CASE NO. SP2020-007

RE: REVISION NARRATIVE – AMENDED SITE PLAN SUBMITTAL

The following changes have been made to the previous approved site plan.

SPR PACKAGING
 OFFICE ADDITION
 1480 JUSTIN RD., ROCKWALL, TEXAS

1 SITE PLAN

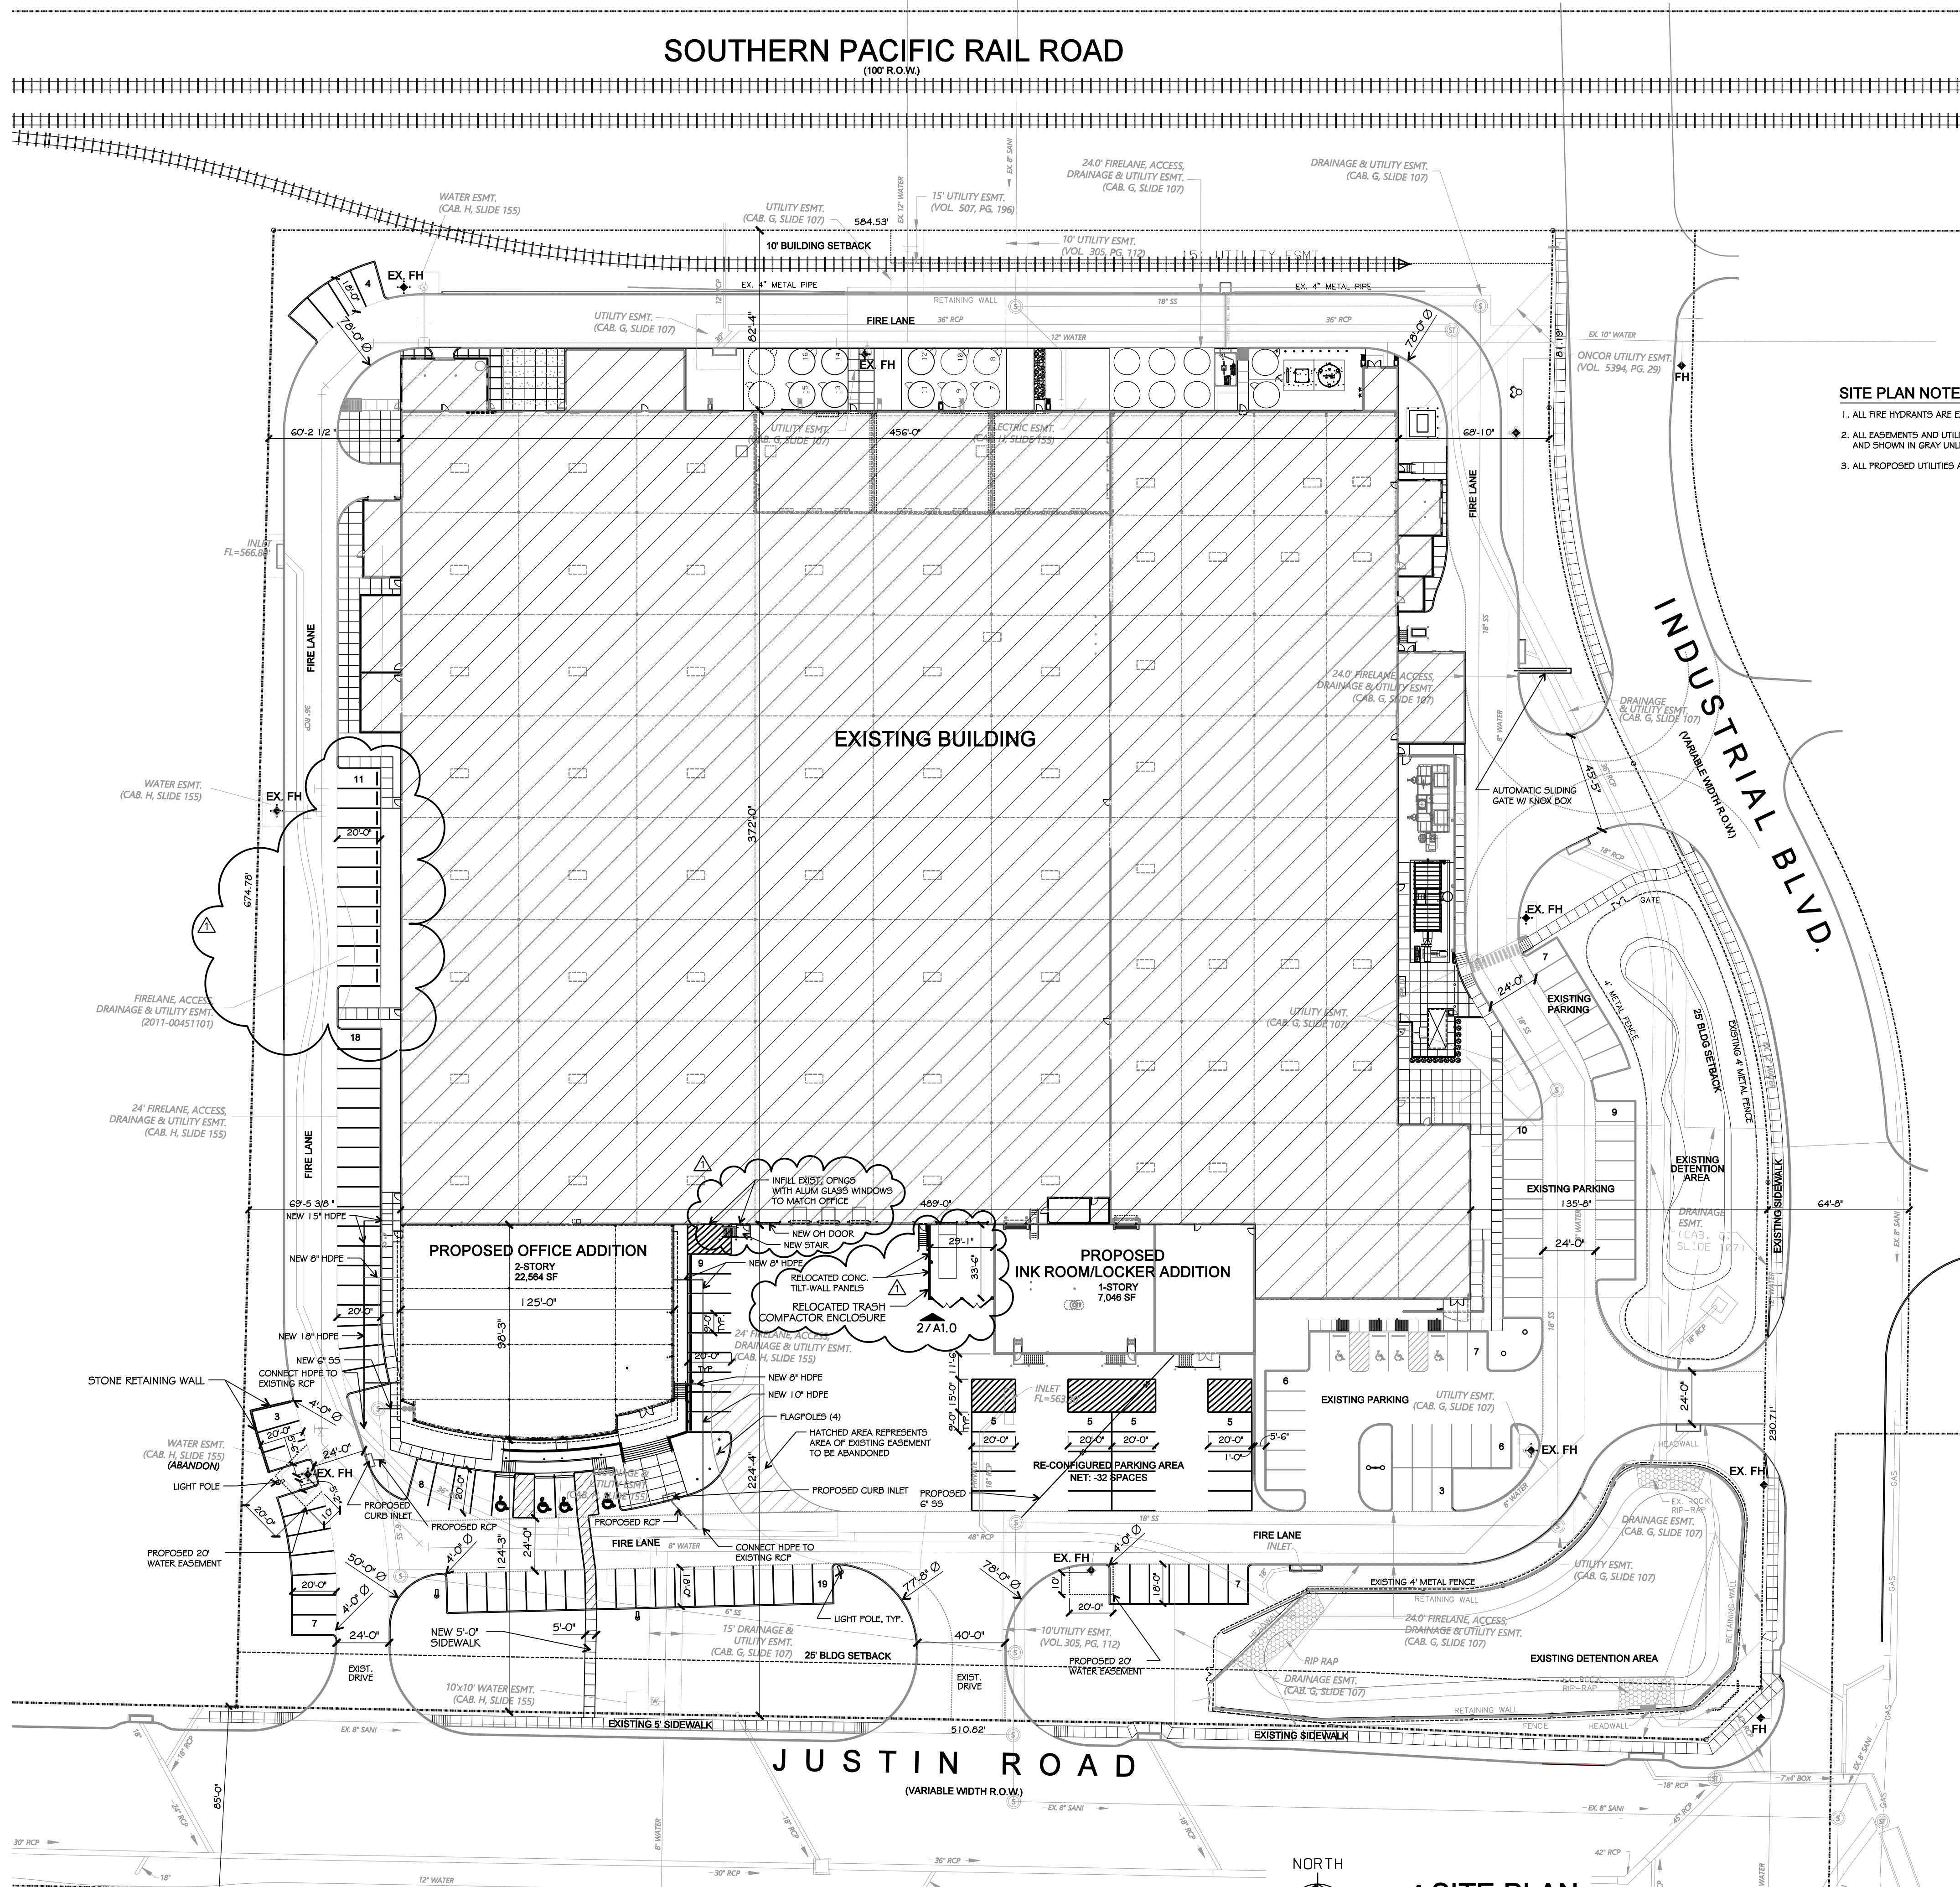
- The compactor enclosure has been moved further east and adjoined to the Ink Room addition exterior wall. The building wall will be protected by a traffic rated guardrail.
- Doors and stairs along the existing south wall have been relocated as needed to accommodate the new location of the compactor enclosure.
- At the existing west drive, the drive lane has been straightened with the Owner's removal of the existing 30" unprotected Bois d'Arc tree. Parking has been reconfigured to add three additional spaces to the site.
- Parking data is updated to reflect the additional parking spaces and the actual number of parking spaces added with the office and ink room additions.

**DEMOLITION /
EXISTING SITE PLAN**
SCALE: 1"=40'-0"

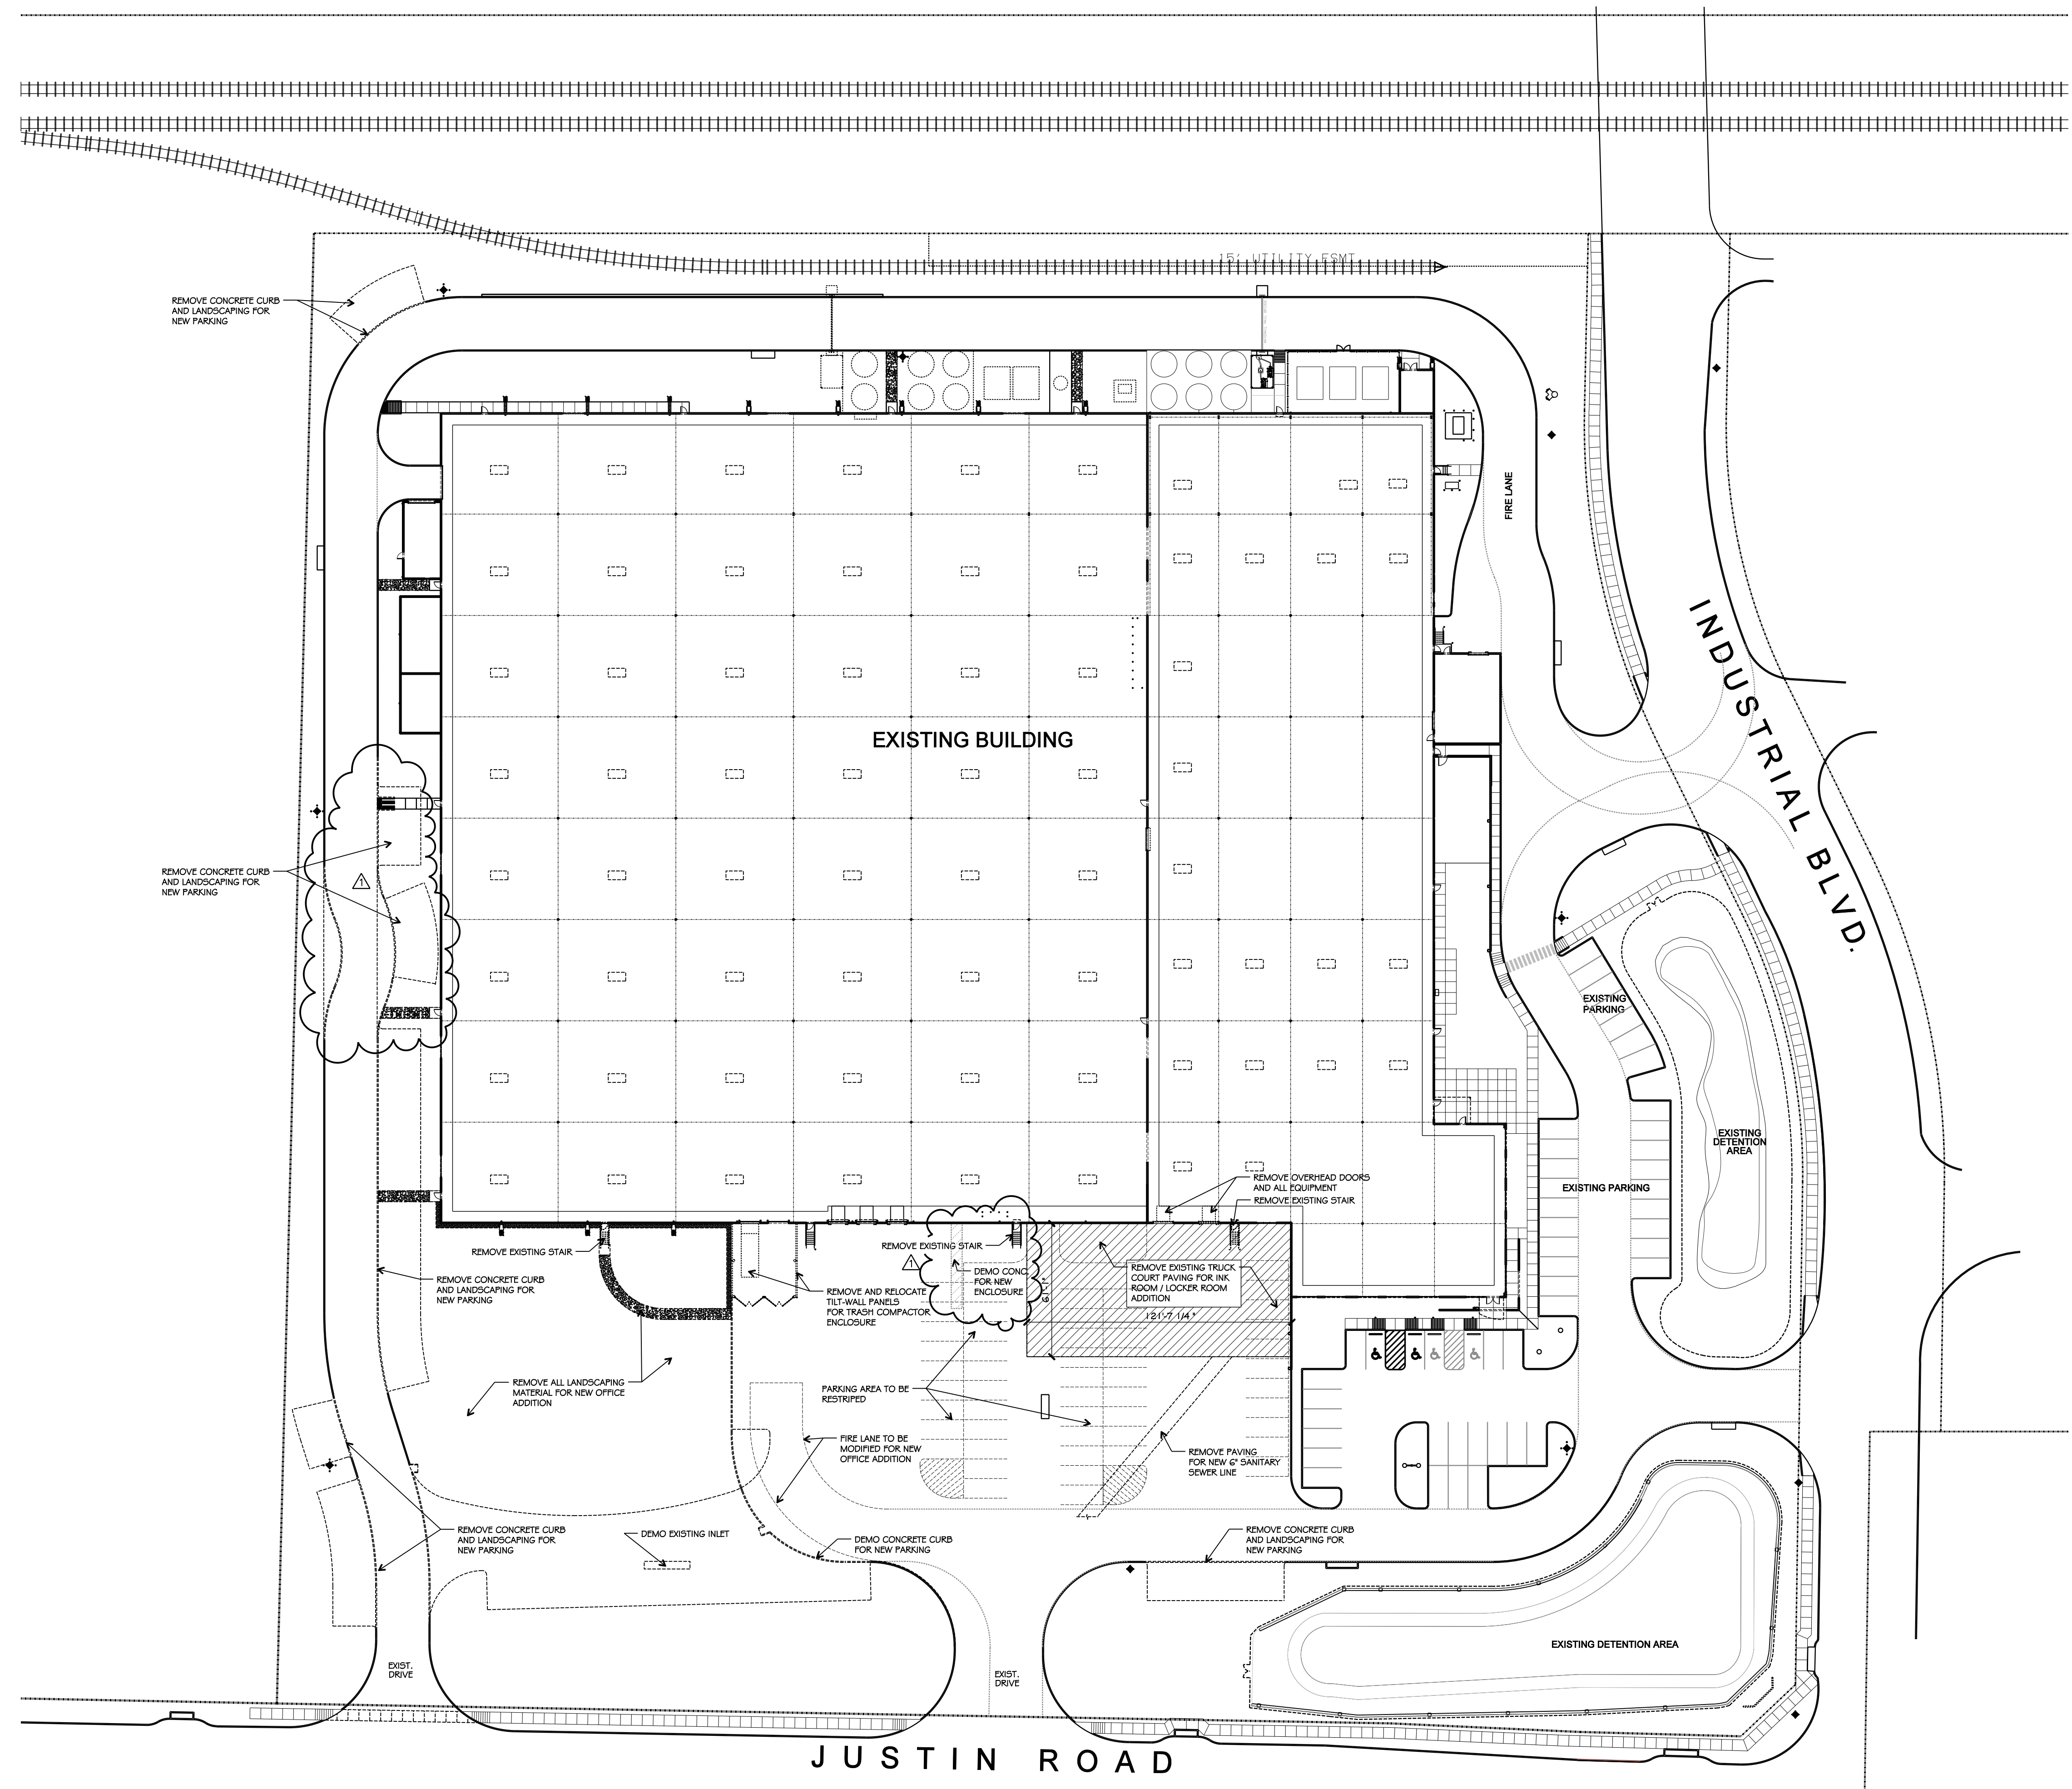
A1.1 Demolition / Existing Site Plan
